Subject: Controller Firmware Release History (System)		Prepared by: A. Ishiyama	
From: 1st Tech. Support Sec. Service Support Dept.			
Classification:	<input type="checkbox"/> Troubleshooting	<input type="checkbox"/> Part information	<input type="checkbox"/> Action required
	<input type="checkbox"/> Mechanical	<input type="checkbox"/> Electrical	<input type="checkbox"/> Service manual revision
	<input type="checkbox"/> Paper path	<input type="checkbox"/> Transmit/receive	<input type="checkbox"/> Retrofit information
	<input checked="" type="checkbox"/> Other ()

This RTB has been issued to announce the firmware history for the System of the Model C-P2c (G113 model).

Model: Model C-P2		Date: 25-Mar-05	No.: RG112009
Subject: Bypas Tray Paper Pick-up Mechanism		Prepared by: A. Ishiyama	
From: 1st Tech. Support Sec. Service Support Dept.			
Classification:	<input type="checkbox"/> Troubleshooting <input checked="" type="checkbox"/> Mechanical <input type="checkbox"/> Paper path <input type="checkbox"/> Other ()	<input type="checkbox"/> Part information <input type="checkbox"/> Electrical <input type="checkbox"/> Transmit/receive	<input type="checkbox"/> Action required <input type="ch

Important Note on the Bypass Feed Mechanism

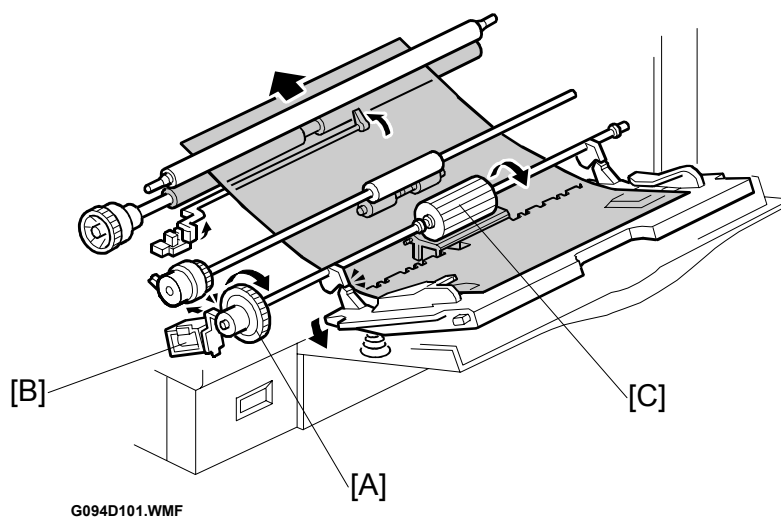
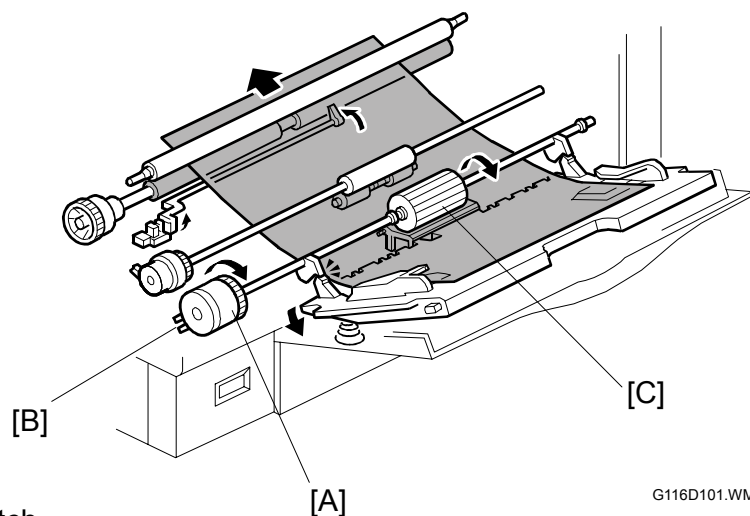
The paper feed mechanism for the bypass tray will be **temporarily** changed from a clutch system to a **solenoid** system. The system will be changed back to the clutch system from around August 2005 production (cut-in S/N TBA).

- This is the same solenoid system that is used on the C-P1/K-P3.
- This change is for the C-P2b/P2c and K-P4.
- See MB MG112003 for the P/N details.

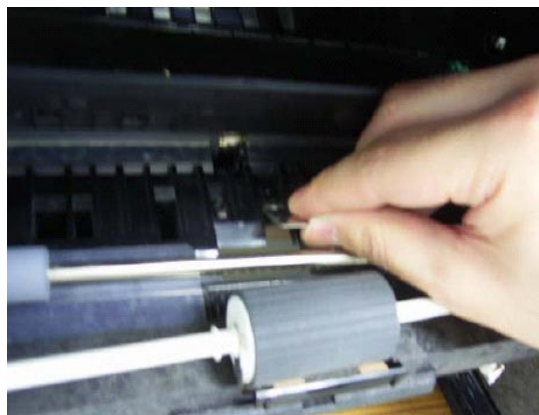
12. Replace the leaf spring (~~G0523303~~) **G0523304**

Old P/N	New P/N	Description	Q'ty	Int	Page	Index	Note
G0963272	G1103272	COVER: MANUAL FEED TABLE	1	O/O	3	10	-

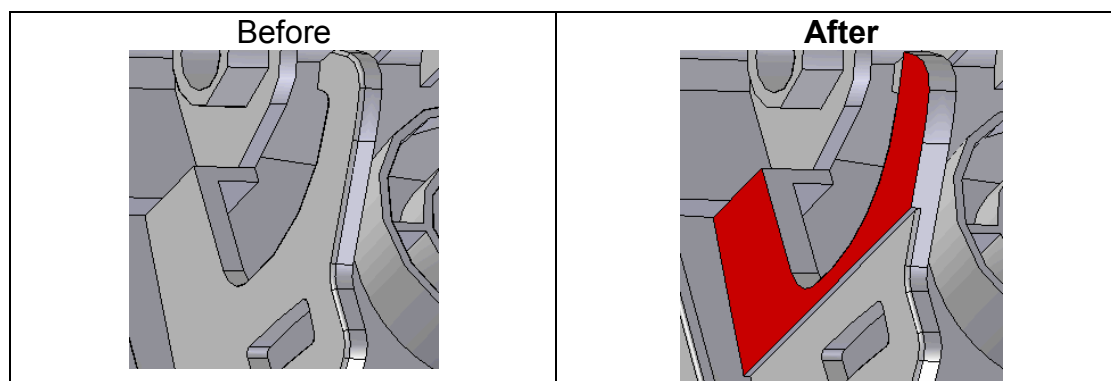
Change: The shape of the hook was changed.

Reason: To improve the durability of the hook.
